## Technical change to HDC HighPower mounting cover

Product Change Notice Number: **PCN-PB72-20251105-00-A**

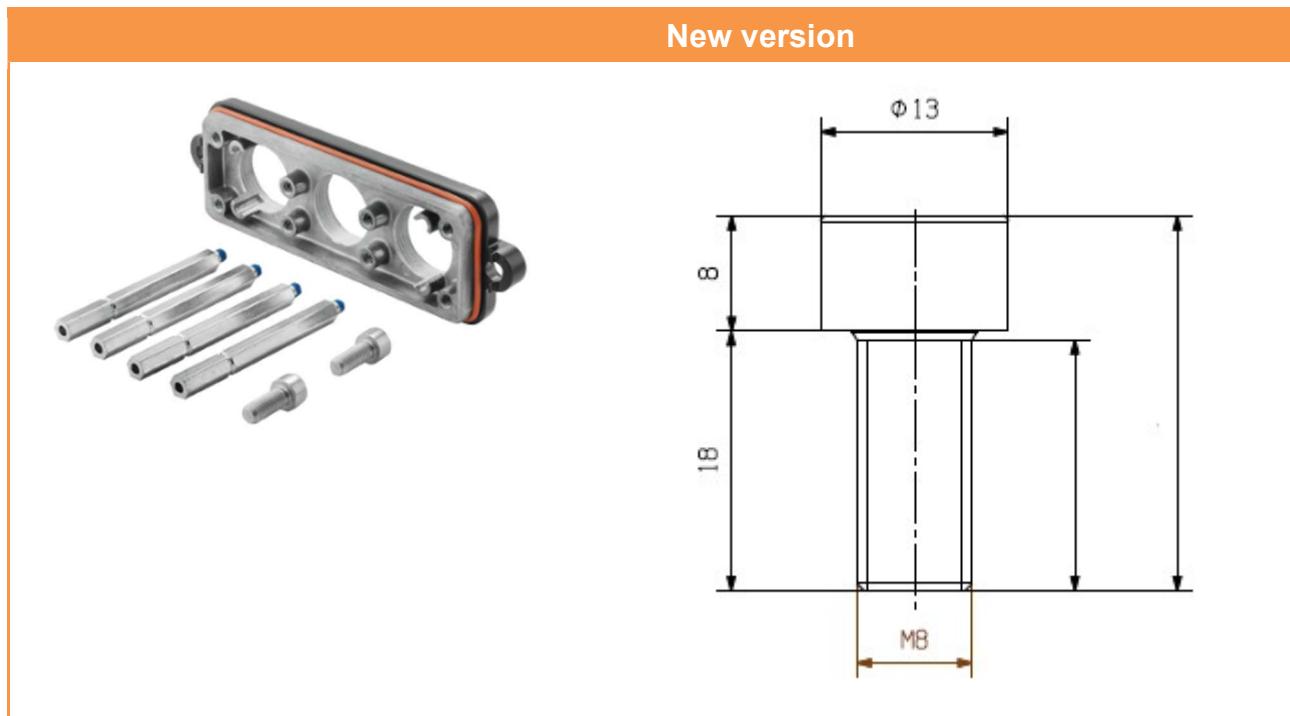
Previously, the M8 thread had a length of 20 mm.

The M8 thread was changed from 20 mm to 18 mm.
